City of Slidell, Louisiana

Olde Towne Preservation District Commission

Location: 1827 Front Street

Request: Certificate of Appropriateness for exterior changes to train platform for ADA compliance

Figure 3: Wheelchair Enclosure and Wheelchair Lift

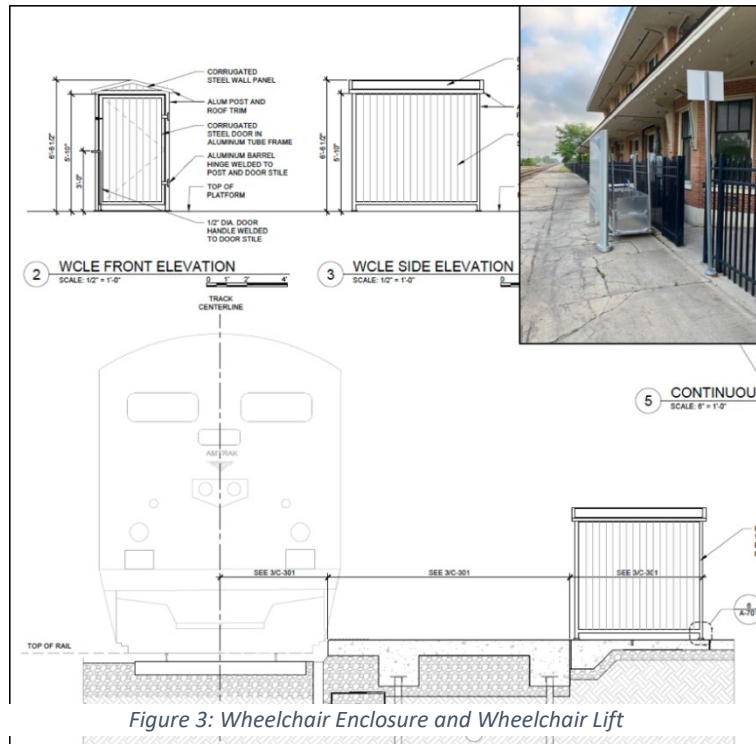
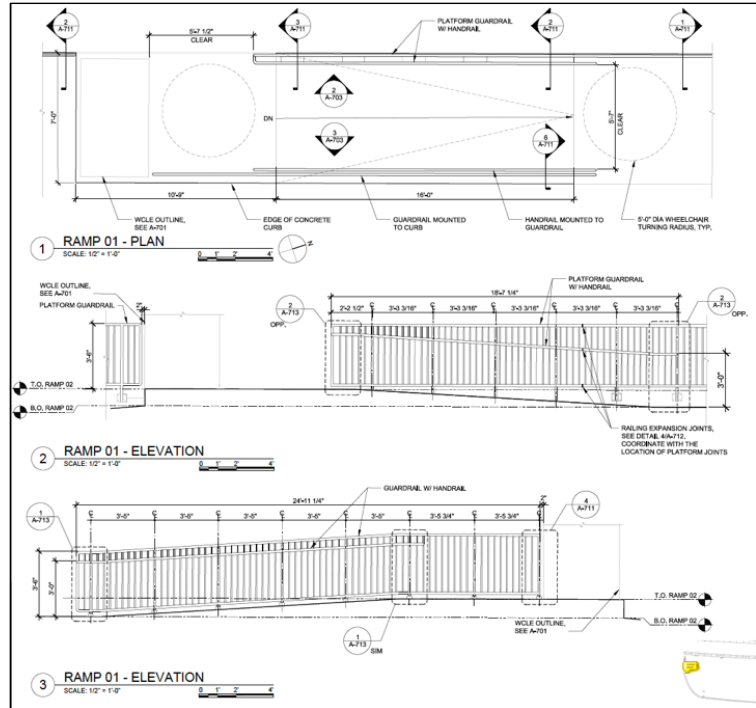
- 1) *Renovation.* AMTRAK proposes to construct a permanent wheelchair structure to house the mobile lift equipment out of the weather and conceal it from street view when not in use.
- 2) *Analysis.* The structure's location on the non-historic train platform will keep it from detracting from the building's historic appearance and therefore should not affect the building's National Register status.
- 3) *Recommendation.* Appropriate.

Figure 4: Light Fixture

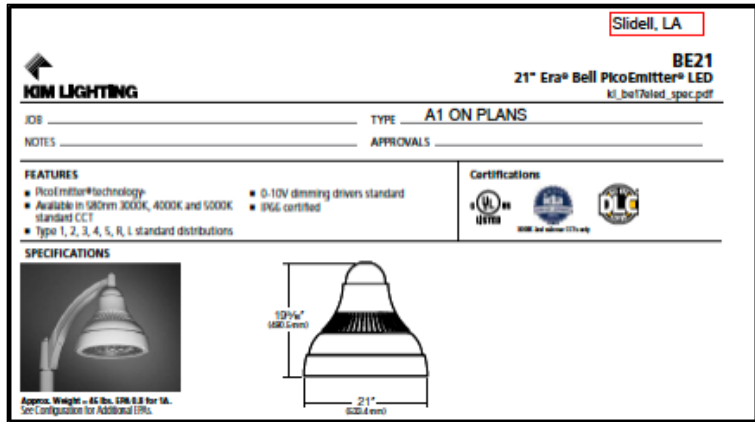
- 1) *Renovation.* New 10' tall black metal light poles are proposed to be added to the platform and ADA walkways.
- 2) *Analysis.* There is no evidence that shows whether the original building design included platform lighting or if original platform lighting was removed years ago. Platform light fixtures were not considered a character-defining element. Therefore, the addition of the light fixtures should not affect the building's National Register status.
- 3) *Recommendation.* Appropriate.

Figure 5: Wayfinding Signage

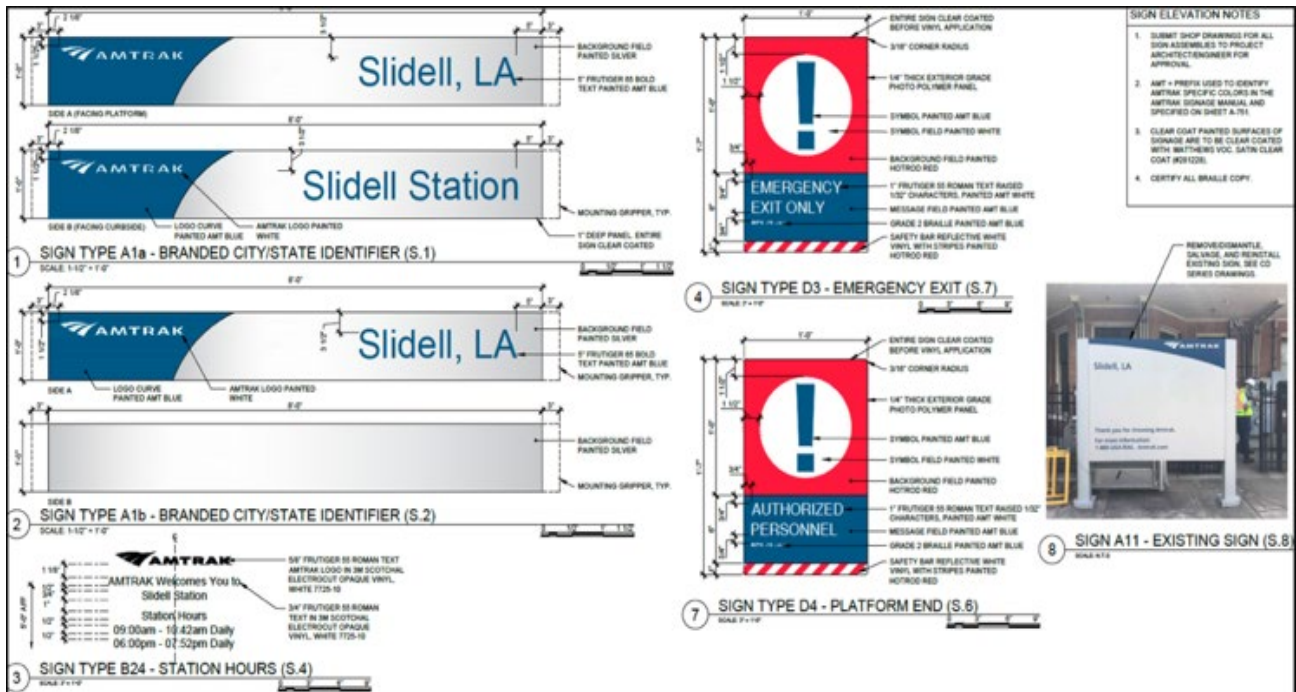
- 1) *Renovation.* The existing signs are proposed to be re-installed and new ADA compliant signage would be added.
- 2) *Analysis.* The wayfinding and ADA signs were added post original construction and were not considered a character-defining element. Their reuse and the addition of required ADA signs should not affect the building's National Register status.
- 3) *Recommendation.* Appropriate.

Figure 7: Current ADA Path and Guardrails

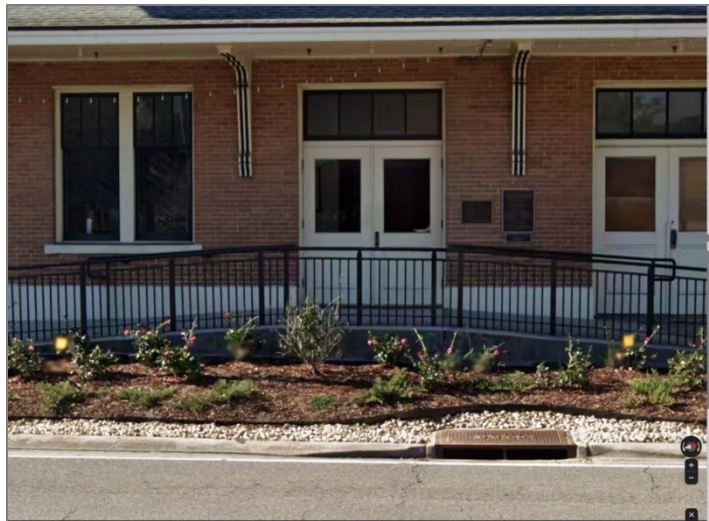
- 1) **Renovation.** Three concrete accessible paths with black metal guardrails would be constructed to connect the platform with the parking lot and AMTRAK waiting area.
- 2) **Analysis.** The addition of concrete ramps and black metal guardrails are consistent with the design of the existing ADA concrete ramps and guard rails (Figure 7). The existing ramps and guardrails were not part of the building's original design and were not considered a character-defining element. Therefore, the addition of proposed walkways, ramps, and guard rails should not affect the building's National Register status.
- 3) **Recommendation.** Appropriate.
